ROGERS BOARD OF ADJUSTMENT MEETING AGENDA

1. (VAR-Fields at Pinnacle) A request by James Dibble for Fields at Pinnacle requesting to a variance from Section 14-732, U-COM/U-NBT Residential Transition Standards requiring an 8' masonry screen wall along the property line at 5501 W. Madison Avenue in the U-COM (Uptown-Core Mixed Use) and the U-NBT (Uptown Neighborhood Transition) zoning district.

Vin Hotel Masonry Wall

To waive the 8' masonry wall requirement required by Sec. 14-732(4.3)(d.)

Site Plan

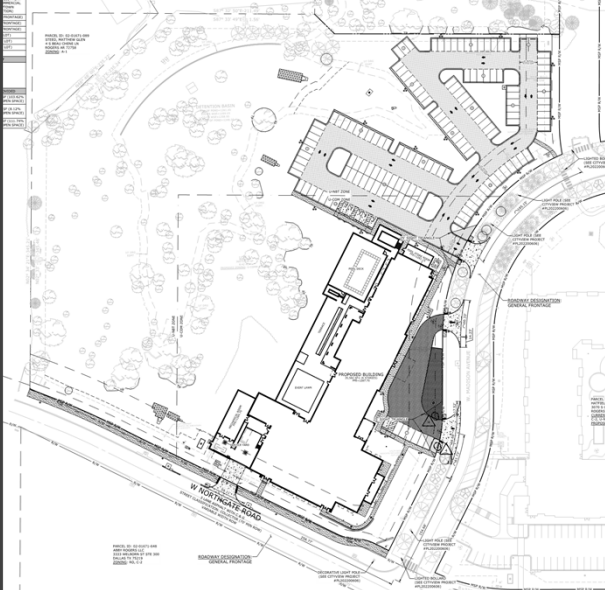
- "An 8' screen wall will require us to remove upwards of 17 existing significant trees and numerous other trees that are currently providing a dense natural screening buffer between the residential lots to the west and our development. Removal of these trees to accommodate for a screen wall will reduce the effectiveness of the existing vegetation."

- "Approval will allow us to keep and maintain the existing stand of trees that are currently providing a dense natural screening buffer along the property line."

Site Plan

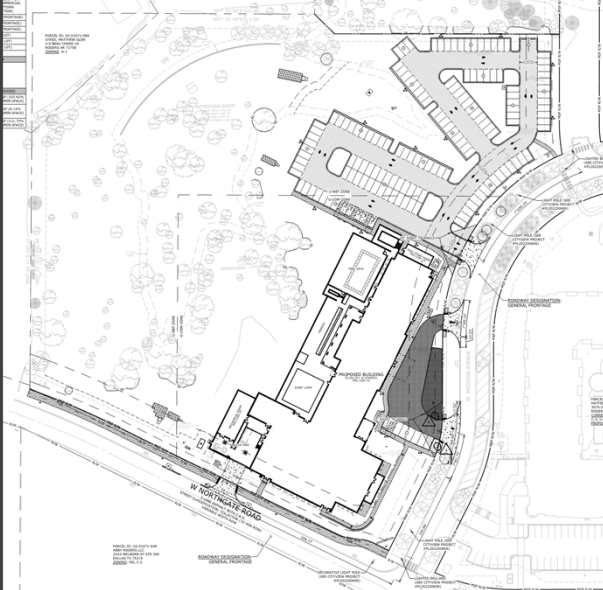
Not particularly. Strict enforcement of the code would require the applicants to build an 8' masonry wall along their western/northwestern property boundary that abuts existing single-family uses. A significant amount of mature trees would have to be removed as a result of this requirement. This is not necessarily a site-specific hardship, unique to this property.

Site Aerial

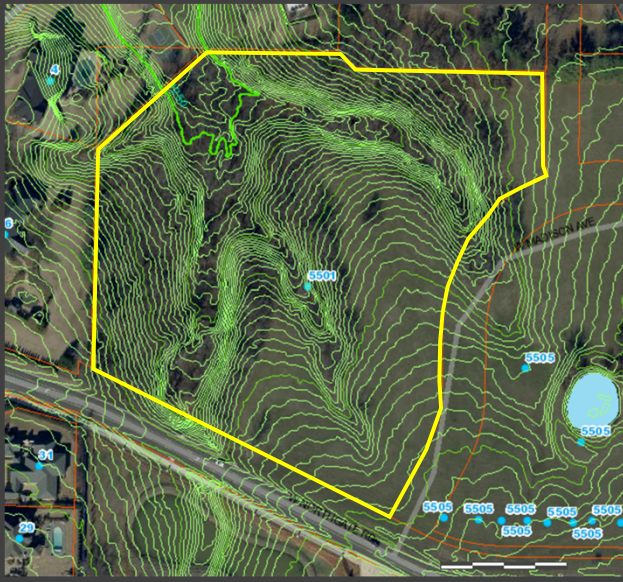
- The forested area west of the hotel serves as a substantial visual buffer for the adjacent single-family homes. The terrain of the site also slopes, somewhat drastically, to the northwest. Because of the proposed preserved vegetation, steep slope of the property, and the required placement of the 8' masonry wall, the wall wouldn't block the view any better than the existing mature tree cover would for the adjacent neighbors.

- No. The difficulty in this instance is the requirement to construct an 8 foot tall masonry wall that runs nearly 800 linear feet.
